INFORMATION BULLETIN

RELEASE OF MCEM FIRMWARE 1.4.0.05

This bulletin announces the production release of Version 1.4.0.05 firmware for the Nielsen Multi-Channel Encoding Monitor. This monitor firmware update, based on client input, contains new features not included in the prior released versions of the monitor.

2. Trace Log Feature

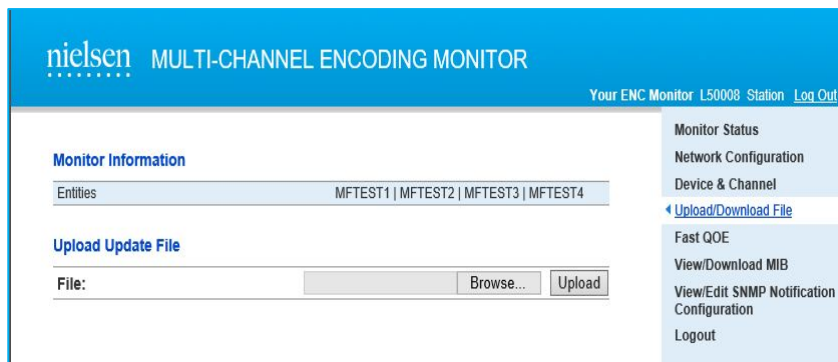
A new trace log feature has been added to the Multi-Channel Encoding Monitors web interface allowing users to test connectivity from their monitor back to Nielsen. This feature generates a log file from the test to be able to more easily diagnose any connectivity issues.
